Access Compliance Report

Public Rights-of-Way

(Curb Ramps)

Intersection ID: 11425	Main Street: AVENING_CT	Cross Street: AVENSONG_CROSSING_DR	Location: NW
ADA ID: D43014A2980E	Ramp Type: BlendTrans1	Initial Pass/Fail: Fail	Overall Compliance: No
		Severity Score: 17.5

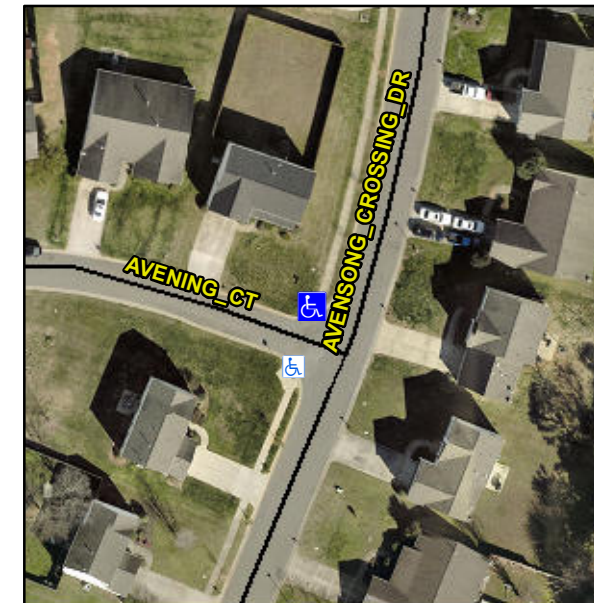
Surveyor Notes:

CURB GAP 1.0, NO LT SW

PROW/ADA:

Not Found, R304.5.1

Possible Solutions:

Remove & Replace Curb Ramp With Two New Directional Ramps or Equivalent.
